From: Jonathan Talley <jon@jtalimited.co.uk>
Sent: 13 January 2025 11:06:29 UTC+00:00
To: "Anna Tidey" <anna.tidey@midsussex.gov.uk>
Cc: "drainage" <drainage@midsussex.gov.uk>
Subject: Re: FW: DM/24/2933 - 23 Meadow Drive Lindfield Haywards Heath West Sussex RH16 2RS
Attachments: 064-001-101 1~30 Flood Map.pdf

Subject: RE: DM/24/2933 - 23 Meadow Drive Lindfield Haywards Heath West Sussex RH16 2RS

Thank you for consulting the Flood Risk and Drainage Team with regard to the above application. We understand the application is for demolition of existing garage and erection of a two storey rear and side extension and new front porch. The Flood Risk Assessment provided by the Applicant has been reviewed, and we would comment as follows:

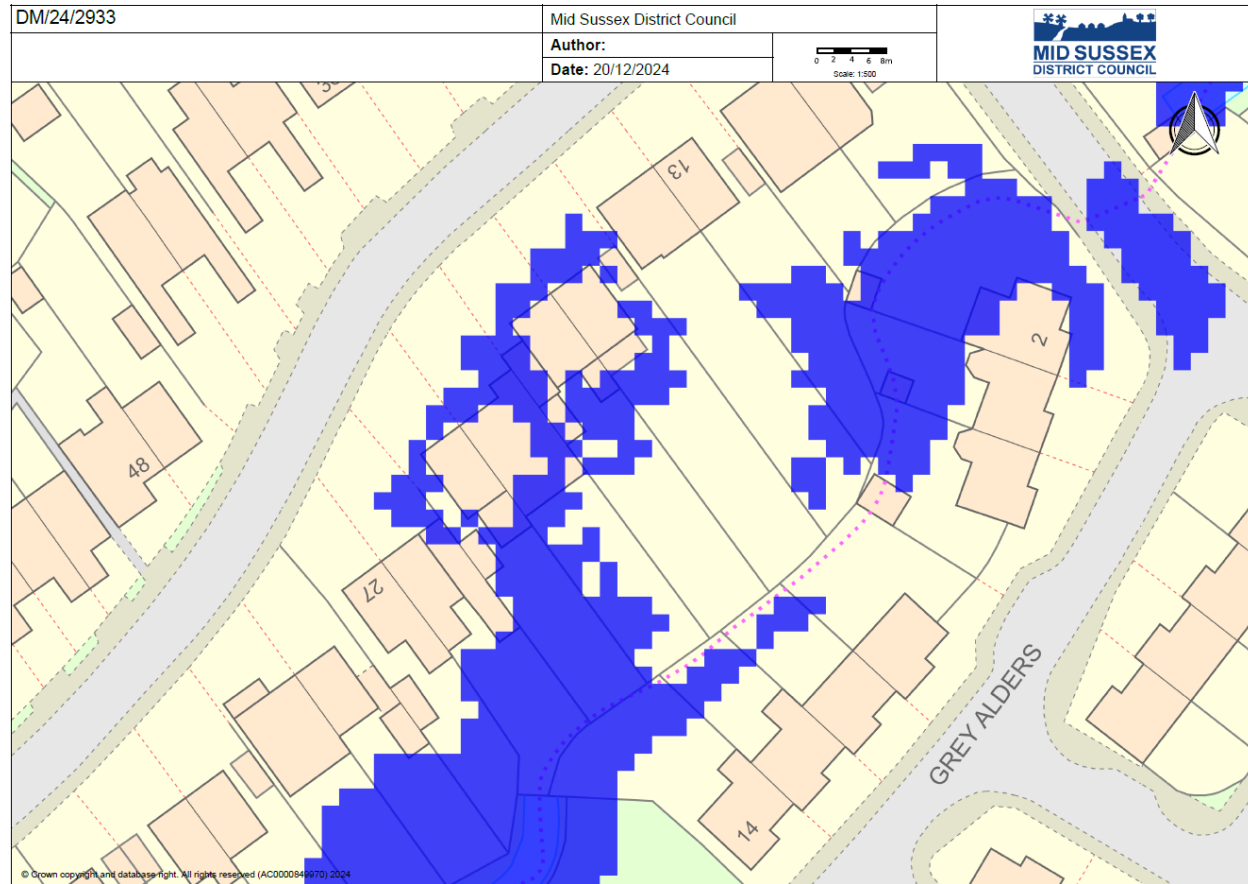
Due to the need to consider all sources of flooding consistently with river flooding, Mid Sussex District Council (in line with West Sussex Lead Local Flood Authority advice) now follow the below table when considering flood risk. The proposed development site is located within an area impacted by the 1:30, 1:100 and 1:1,000 flood events (high, medium, and low surface water flood risk). Following the approach set out under the NPPF for assessing fluvial flood risk (flood zones) this area would be considered consistent with Flood Zone 3b (1:30 extent), Flood Zone 3a (1:100 extent), and Flood Zone 2 (1:1000 extent).

Based on the latest guidance that all sources of flooding should be considered consistently the site meets one of the reasons an area would be considered functional floodplain (Flood Zone 3b); it's location within the 1:30 surface water flood extent.

It is the Flood Risk and Drainage Team's findings that, following the latest guidance on assessing flood risk the site is located within the equivalent of Flood Zone 3b (1:30 flood extent) and the proposed development is a more vulnerable development.

As per the Environment Agency standing advice for minor extensions, development within the 1:30 flood extent is not permissible.

- In order to assist please see above extract from our Environment Agency mapping of the surface water flood extents. There is a publicly available searchable and downloadable maps available: Defra Data Services Platform (select the relevant layers for the 1:30, 1:100 and/or 1:1000 extents) Please could the Applicant overlay their proposed extension footprint on the above (or similar) screenshot of the 1:30 flood extent for us to review any encroachment?

If the proposal is outside of this extent then additional resistance and resilience mitigation will need to be evidenced at this location, as this development is classified as 'more vulnerable'.

In addition, the Flood and Drainage Team would have no objection to the scheme if surface water modelling can be provided which demonstrates that the development design ensures that, for the 1:100 year + climate change event:

- Site users are safe in the event of a flood
- There is no loss of floodplain storage
- There is no impedance of overland flows
- There is no increase in flood risk

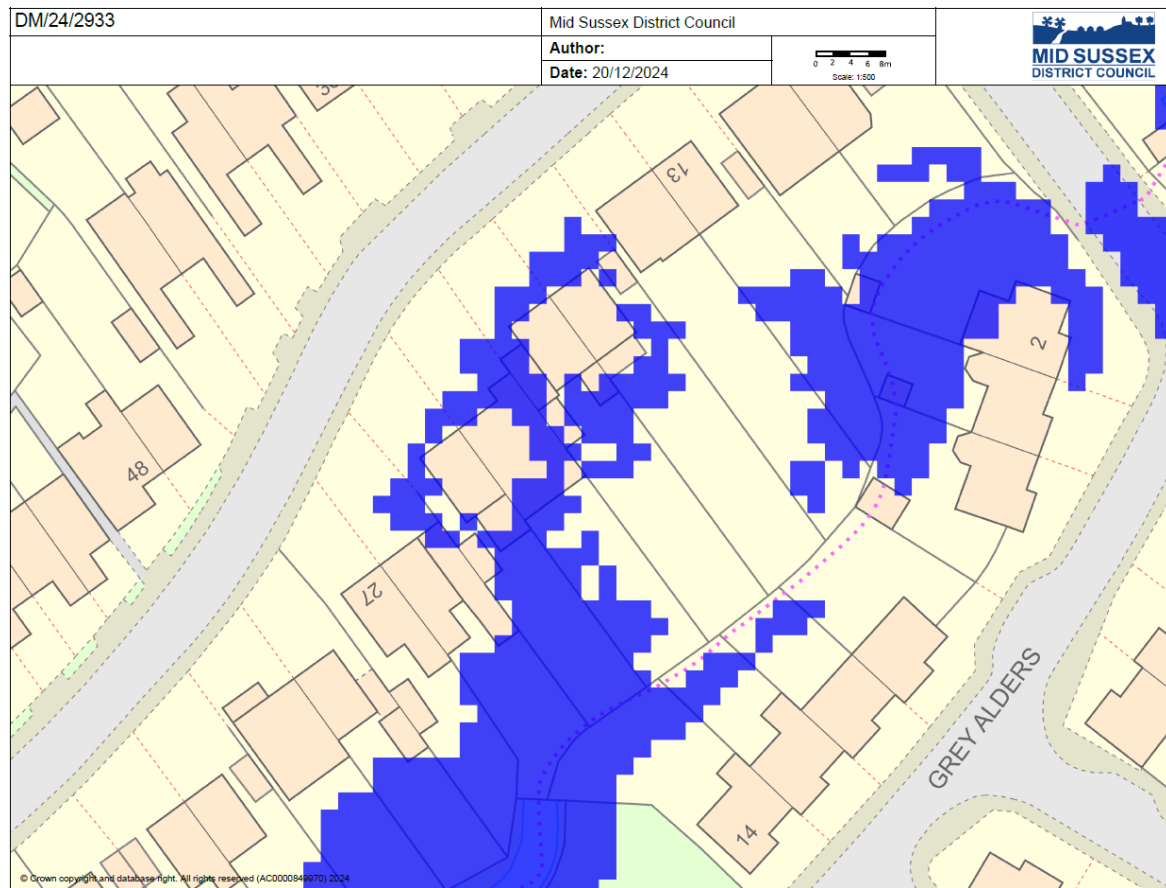
The proposed development site is located within an area impacted by the 1:30, 1:100 and 1:1,000 flood events (high, medium, and low surface water flood risk). Following the approach set out under the NPPF for assessing fluvial flood risk (flood zones) this area would be considered consistent with Flood Zone 3b (1:30 extent), Flood Zone 3a (1:100 extent), and Flood Zone 2 (1:1000 extent).

Based on the latest guidance that all sources of flooding should be considered consistently the site meets one of the reasons an area would be considered functional floodplain (Flood Zone 3b); it's location within the 1:30 surface water flood extent.

It is the Flood Risk and Drainage Team's findings that, following the latest guidance on assessing flood risk the site is located within the equivalent of Flood Zone 3b (1:30 flood extent) and the proposed development is a more vulnerable development.

As per the Environment Agency standing advice for minor extensions, development within the 1:30 flood extent is not permissible. In the event that the proposal is outside of this extent then additional resistance and resilience mitigation will need to be evidenced at this location, as this development is classified as 'more vulnerable'

In addition, the Flood and Drainage Team would have no objection to the scheme if surface water modelling can be provided which demonstrates that the development design ensures that, for the 1:100 year + climate change event:

- Site users are safe in the event of a flood
- There is no loss of floodplain storage
- There is no impedance of overland flows
- There is no increase in flood risk
